Access Compliance Report

Public Rights-of-Way

(Curb Ramps)

Intersection ID: 50512	Main Street: EVERSFIELD_LN	Cross Street: MERIDALE_CROSSING_DR	Location: S
ADA ID: 864C9D924CA5	Ramp Type: PerpDiag	Initial Pass/Fail: Fail	Overall Compliance: No
Severity Score: 22.5			
Codes/Mitigation Info/Possible Solution		Field Measurements/Component Compliance

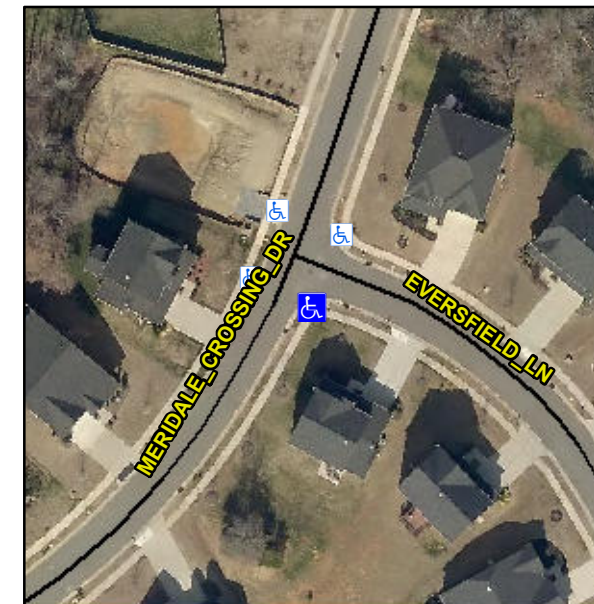
Not Found, R304.5.1, R304.2.2, R304.5.3

Compliance	Description	Data	Compliance	Description	Data
N/A	Ramp Length (in)	47.0	No	Ramp Slope (%)	10.2
No	Ramp Width (in)	47.5	No	Ramp XSlope (%)	2.2
N/A	Flare Type LT	N/A	N/A	Flare Type RT	N/A
N/A	Flare Slope LT (%)	N/A	N/A	Flare Slope RT (%)	N/A
N/A	Flare Traversable LT?	N/A	N/A	Flare Traversable RT?	N/A
N/A	Landing Length (in)	N/A	N/A	DWS Provided?	N/A
N/A	Landing Width (in)	N/A	N/A	DWS Contrast?	N/A
N/A	Landing Slope (%)	N/A	N/A	DWS Length (in)	N/A
N/A	Landing X Slope (%)	N/A	N/A	DWS Full Width?	N/A
N/A	Landing Curb? (Y/N)	N/A	N/A	DWS Offset (in)	N/A
N/A	Shared Landing?	N/A			
N/A	Gutter Ponding?	N/A	N/A	Gutter Slope (%)	N/A
N/A	Gutter Lip Ht (in)	N/A	N/A	Gutter X Slope (%)	N/A
N/A	Painted X Walk1?	No	N/A	Painted X Walk2?	No
	X Walk 1 Direction	To NE		X Walk 2 Direction	To NW
N/A	X Walk 1 Width (in)	N/A	N/A	X Walk 2 Width (in)	N/A
	X Walk 1 Slope (%)	1.6		X Walk 2 Slope (%)	1.4
	X Walk 1 X Slope (%)	0.4		X Walk 2 X Slope (%)	0.8

Remove & Replace Curb Ramp With Two New Directional Ramps or Equivalent.
